ADDENDA NO. 01

Project Name: Los Venados Booster Pump Station
Replacement

Subject: Addenda No. 01

Project No.: CITY BID NO. 2019-82
ROE: 18012

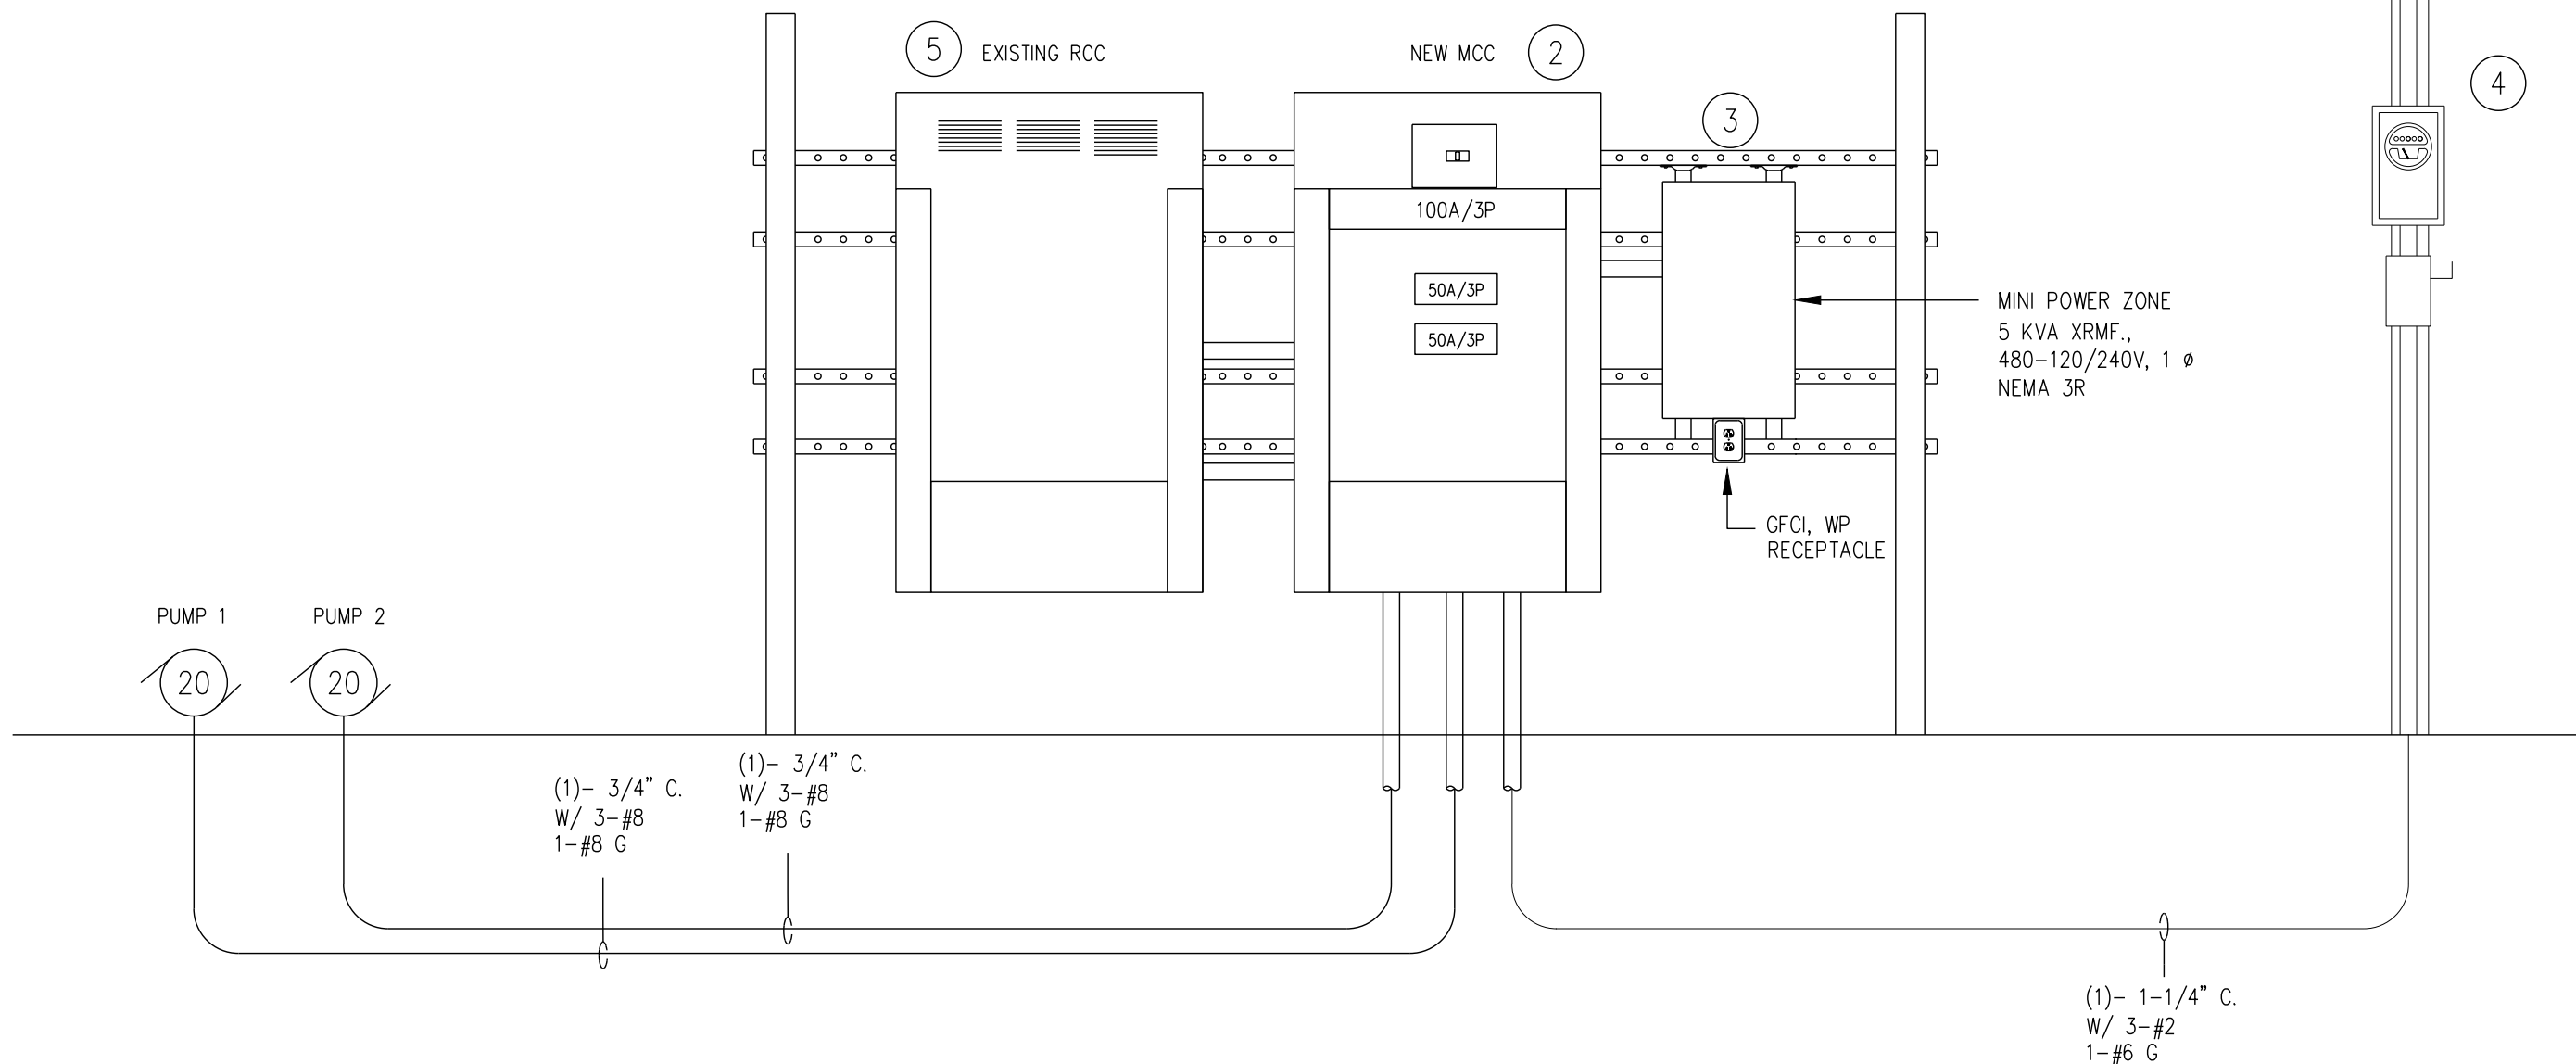
- Item 1 Site layout was updated. Refer to sheet ES1.0.
- Item 2 Existing power pole, weather head and meter will remain. Provide new 100AF/3P/N3 disconnect. Refer to sheet E3.0 Note 4.

- Item 3 Added pressure relief switch at pipe riser before pumps. Refer to sheet ES1.0 Note 6 and ES2.0 Note 9.
- Item 4 Removed area light. Refer to sheet ES2.0.

- ① EXISTING RISER POLE AND METER TO REMAIN.
- ② EXISTING RTU TO REMAIN AND REPAIRED. REFER TO ES2.0 FOR NEW SCOPE OF WORK.
- ③ EXISTING MCC TO BE DEMOLISHED. REFER TO ES2.0 FOR NEW SCOPE OF WORK.
- ④ EXISTING PUMPS TO BE DEMOLISHED. REFER TO ES2.0 FOR NEW SCOPE OF WORK.
- ⑤ CHLORINE ROOM TO REMAIN.
- ⑥ PROVIDE TAP FOR PRESSURE CONTROL SWITCH HERE. REFER TO ES2.0.

1 ELECTRICAL RISER DIAGRAM
N.T.S.

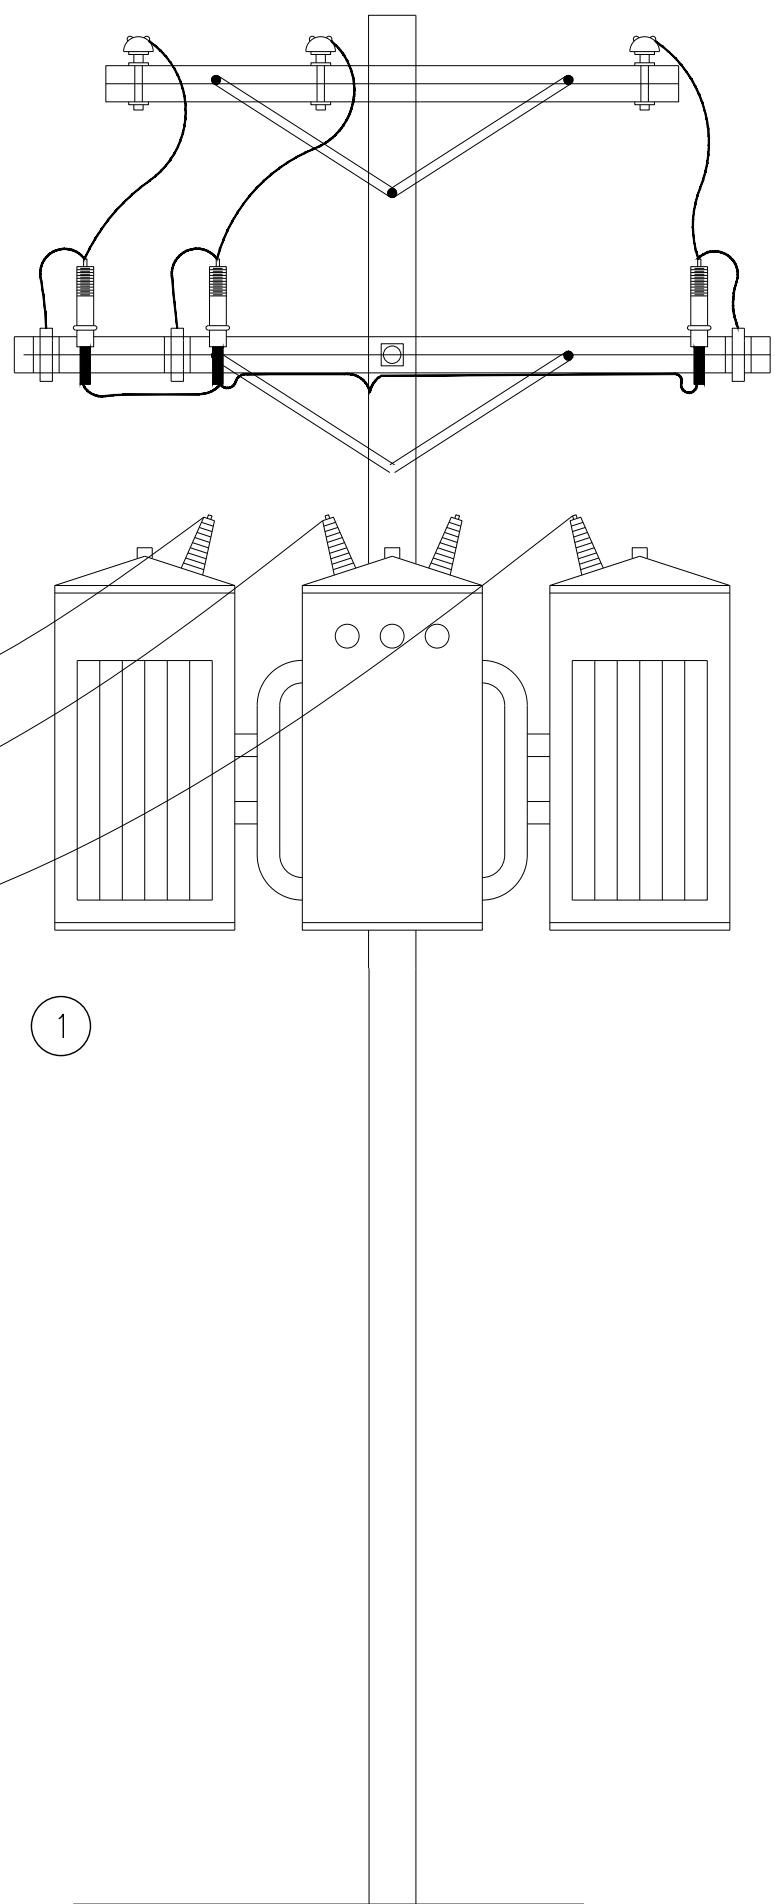
- Item 5 Replace RTU enclosure with new NEMA 4X stainless steel enclosure provided by municipal pumps & controls. Remove existing back plate and reinstall on new enclosure. Coordinate integration and connections of equipment with Municipal Pumps & Controls, Inc. Contact at 956-790-8430. Refer to sheet ES2.0 Note 8 and E3.0 Note 5.

- 1 CONTRACTOR TO COORDINATE WITH UTILITY COMPANY FOR ADDITIONAL REQUIREMENTS TO INCLUDE BUT NOT LIMITED TO CT AND METER.
- 2 REFER TO DETAIL 1/E4.0.
- 3 PROVIDE MINI POWER ZONE 5 KVA XRMF., 480-120/240V, 1 ϕ , NEMA 3R, 10 SPACES ON BACKSIDE OF PANEL.
- 4 PROVIDE NEW 100AF/3P/N3 DISCONNECT. EXISTING METER TO REMAIN.
- 5 REPLACE RTU ENCLOSURE WITH NEW NEMA 4X STAINLESS STEEL ENCLOSURE. REMOVE EXISTING BACK PLATE AND REINSTALL ON NEW ENCLOSURE. COORDINATE INTEGRATION AND CONNECTIONS OF EQUIPMENT WITH MUNICIPAL PUMPS & CONTROLS, INC. CONTACT AT 956-790-8430. COORDINATE RADIO COMMUNICATIONS WITH ANTENNA TO BE INSTALLED ON NEW STANDPIPE

SHEET: **E4.0**

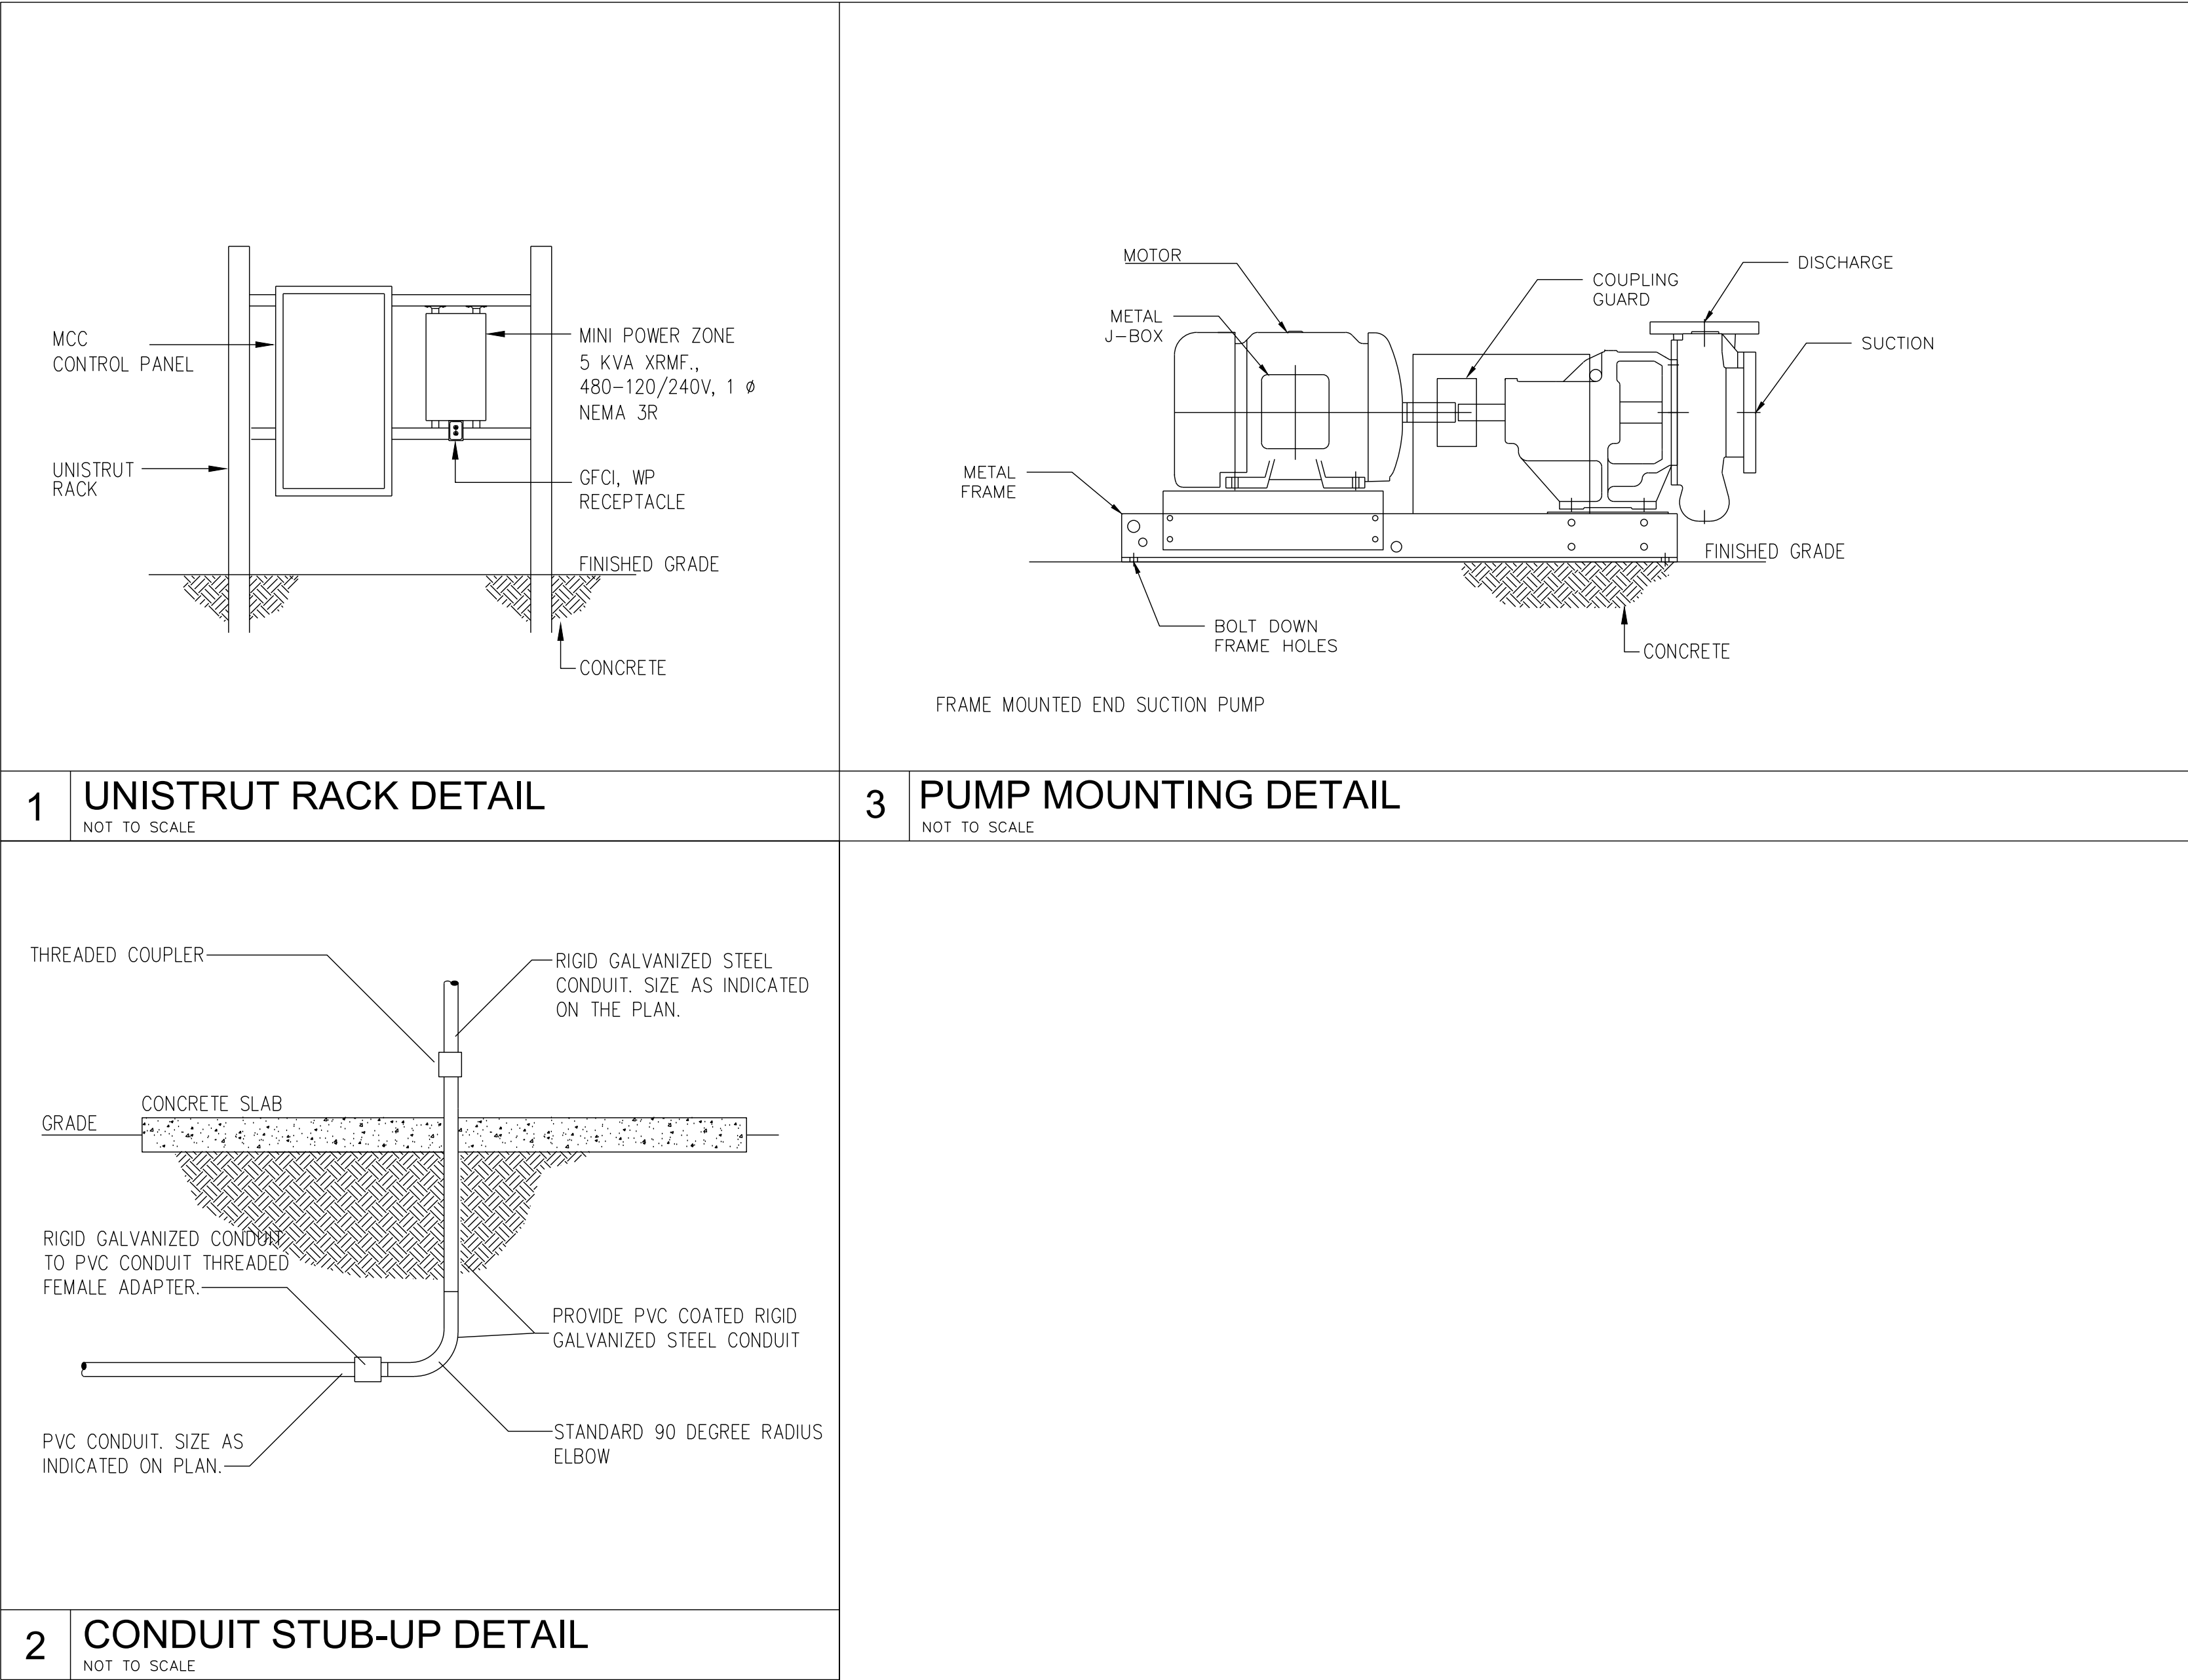
- Item 6 Removed schematics, one-line, and panel riser and dimensions previously on sheet E.4.0 and E5.0. Details are now on sheet E4.0. Contractor shall provide panel with necessary I/O inputs ready for Municipal Pumps & Controls, Inc. to integrate with SCADA Communications using the existing RTU.
